**GUARDIAN SELF STORAGE**

#99-8  
GUARDIAN SELF STORAGE S.P.  
SQUARE HILL ROAD (HAZEN)

**SUBJECT: GUARDIAN SELF-STORAGE SITE PLAN (P.B. # 99-8)**

**REVIEW NAME:** GUARDIAN SELF STORAGE SITE PLAN  
**PROJECT LOCATION:** SQUARE HILL ROAD (a/k/a LINER ROAD)  
SECTION 4-BLOCK 1-LOT 4  
**PROJECT NUMBER:** 99-8  
**DATE:** 9 JUNE 1999

1. 10/10/2001 10:00 AM  
 2. 08/27/2001 10:00 AM  
 3. 07/20/2001 10:00 AM  
 4. 07/13/2001 10:00 AM  
 5. 07/06/2001 10:00 AM  
 6. 06/29/2001 10:00 AM

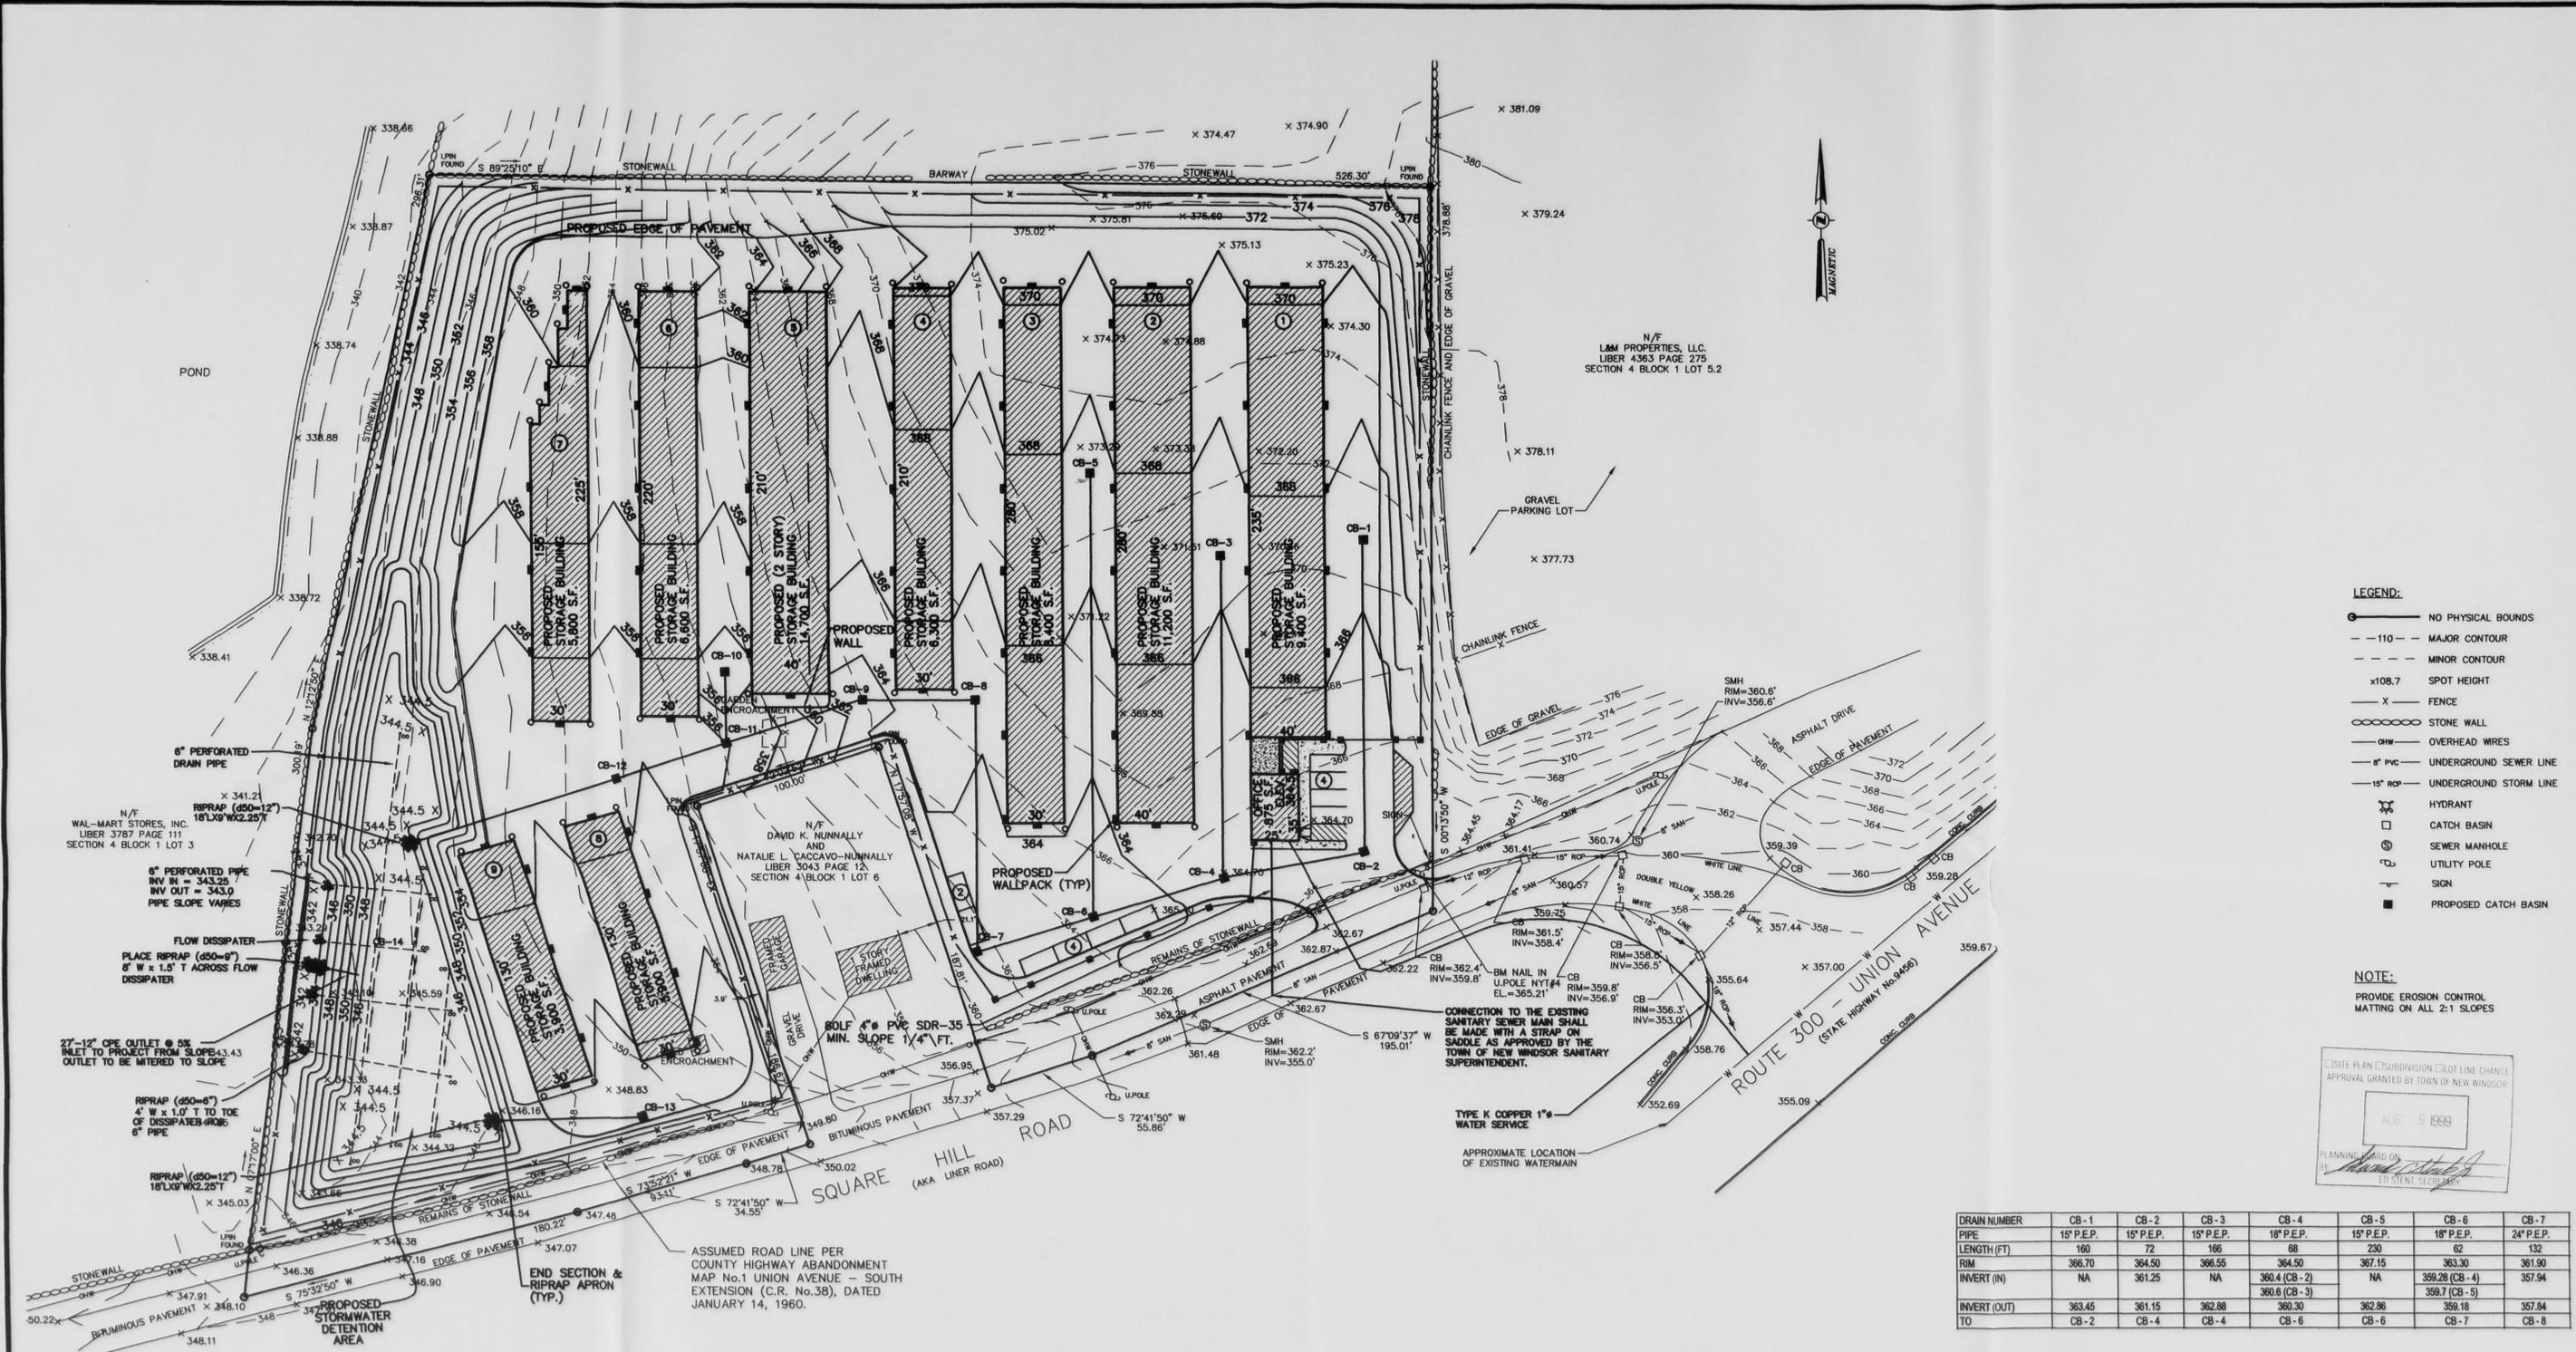
2. The detention pond, as designed, will contain 4.4 feet of water below the discharge of the outlet control structure. No method of discharge for this water is provided. The Town of New Windsor Policy requires detention ponds drain between storm events. The capacity of the first flush treatment would be significantly diminished if existing water was contained in the pond prior to the storm event. A low flow outlet of some sort should be provided in order to provide for draining of the pond between storm events.

3. A section of rip-rap slope protection is identified on the plan sheets, however, a catch basin could be provided at the location of the rip-rap slope protection discharging to the detention pond inlet. This would eliminate the need for over land flow in this area and would allow for the installation of curbing as depicted on the site.

- d. The bulk table should delete the word "minimum" relative to the proposed storage unit height.
  - e. Additional explanation should be provided as to the purpose of the "rip-rap slope protection" depicted on Sheet C-3. Further, explain why this is only provided in the limited area shown.

The bottom of the basin was raised from elevation 340 to 344.5 and the basin was reconfigured. An exfiltration system was added to provide for draining of the pond between storm events.

**SITE DETAILS**

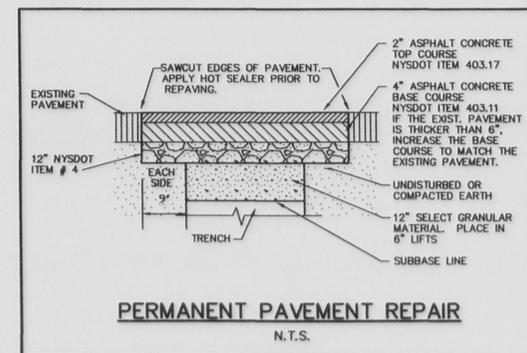
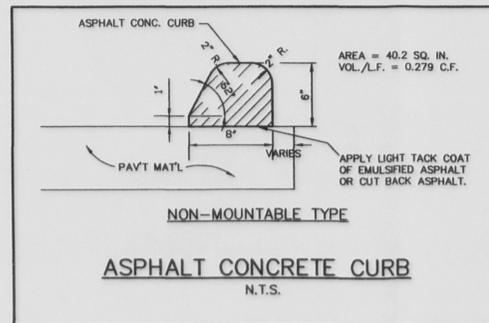
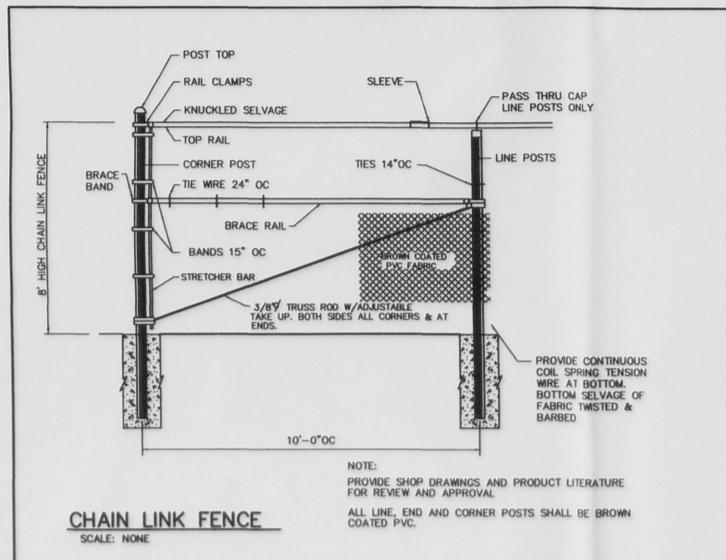
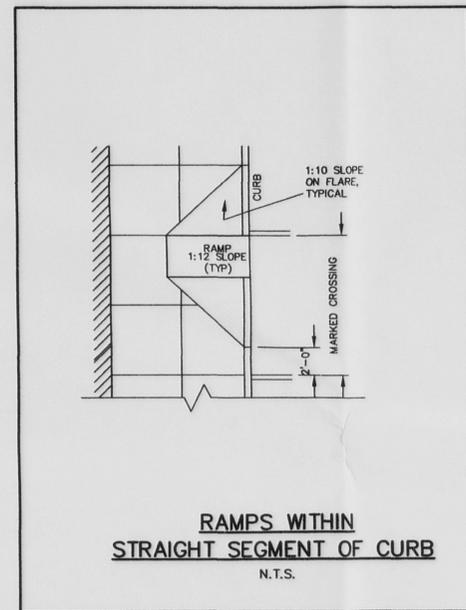
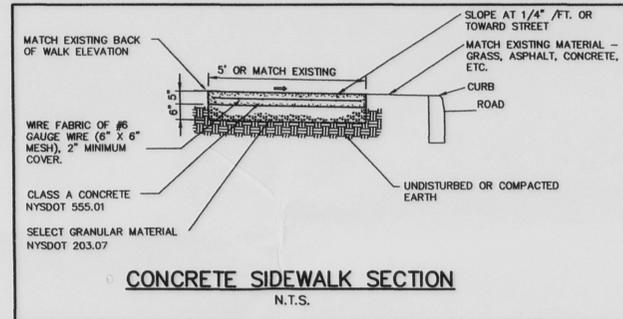
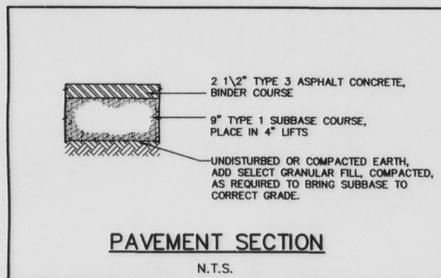
- f. On Detail Sheet C-4, the water connection detail would appear to be non-relevant for the details of this site construction.
  - g. On Detail Sheet C-5, a detail for the concrete curbing of the site entrance should be provided.

- h. On detail Sheet C-5, the "permanent pavement repair" should note that same is applicable for Town roadway pavement replacement. The detail should also be revised to indicate 12" NYSDOT Item #4.

2.f. The water connection detail in question has been removed from the plans and the correct detail has been shown.

2.g. A detail for concrete curbing has been shown on the detail sheet.

2.h. The permanent pavement repair detail has been revised to reflect 12" depth of NYSDOT Item #4.
